Re: Oak Creek Condominiums Public Hearing Follow-up

We received the Notice of Public Hearing and have reviewed the preliminary drawings available through the Development Project link on the RHS website. We are submitting these questions in advance of the hearing which we will be attending on Tuesday.

Preliminary Site Plan (C2.1) and Preliminary Utility Plan (C4.1):

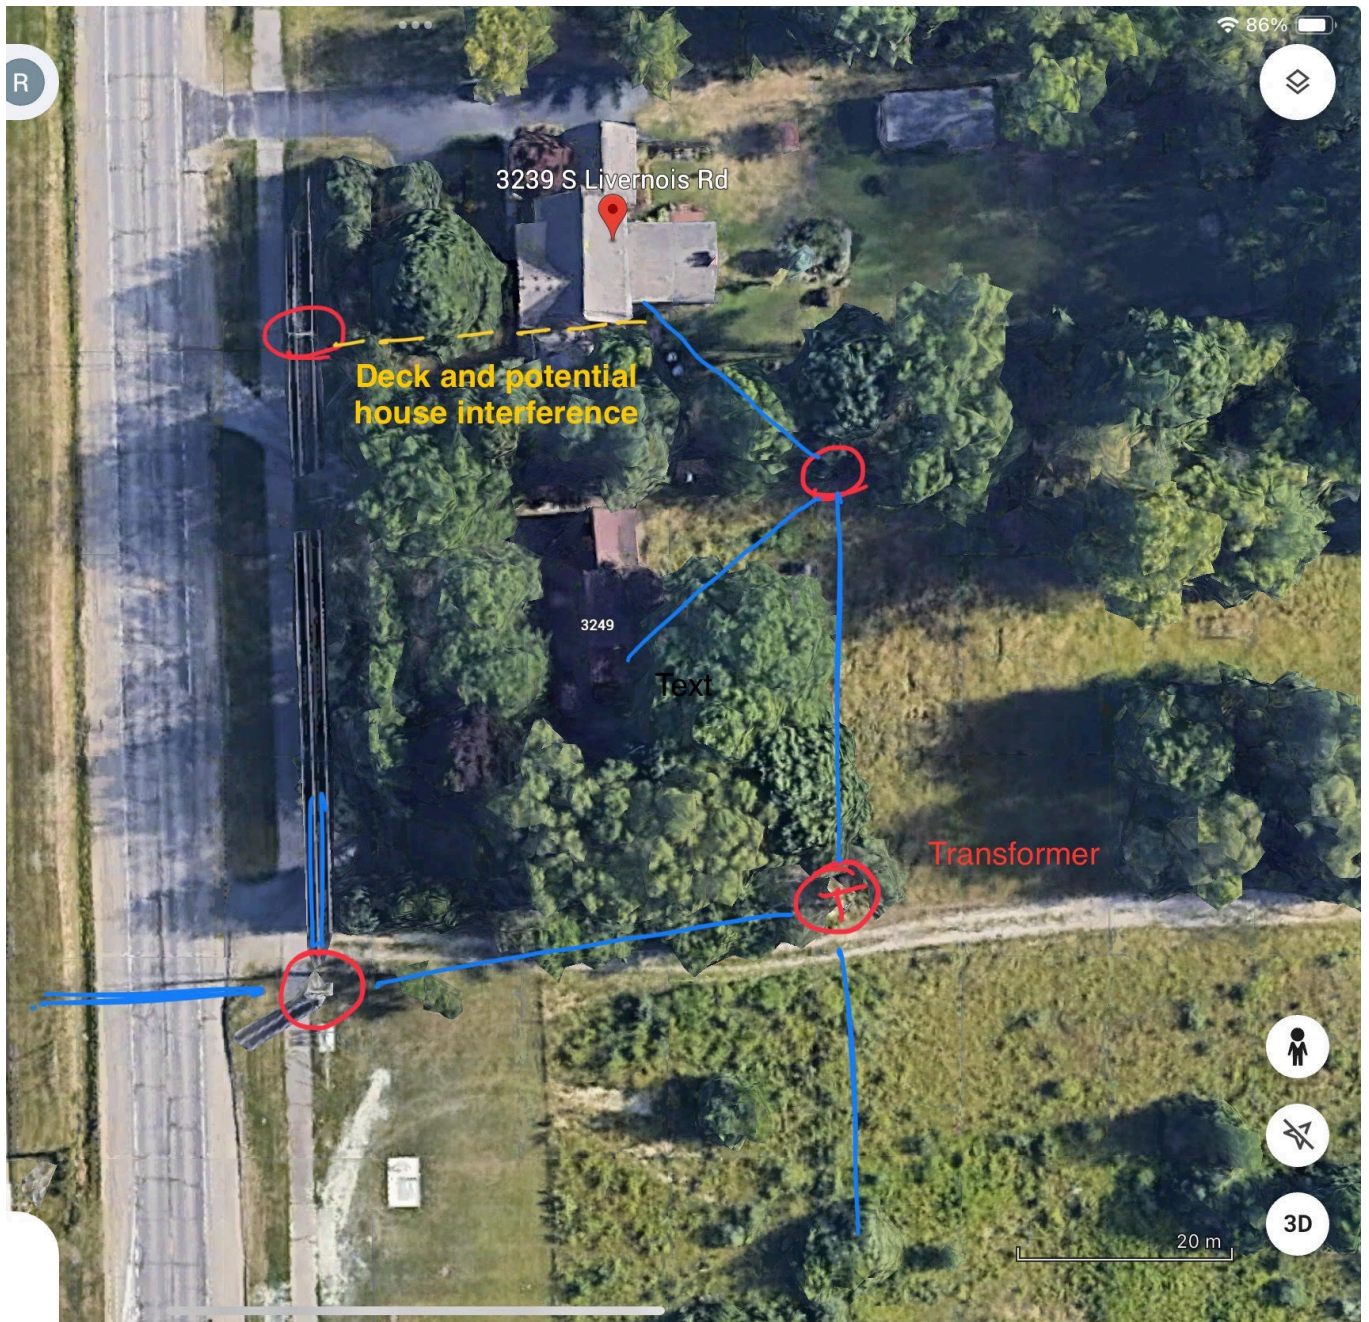
This proposed routing is going to be a big issue for us. Bringing a power line from that front pole directly to the back of our house will mean that we have a low hanging, high voltage power line over our small shed and deck. There also may not be a direct line of sight to the corner of the house above the meters where the line attaches today. I have attached a quick google earth mark up as a visual.

This is a very big safety concern for us not to mention the aesthetic impacts. We request they look at alternatives including possibly going underground.

I always recommend that you bring up whatever concerns/comments you have. That is the purpose of the meeting. However, please note, that with these ultimately being the jurisdiction of DTE we don't always have a say about where poles/lines end up being run. But that conversation can at least be started and the applicant can see if there are potential alternatives.
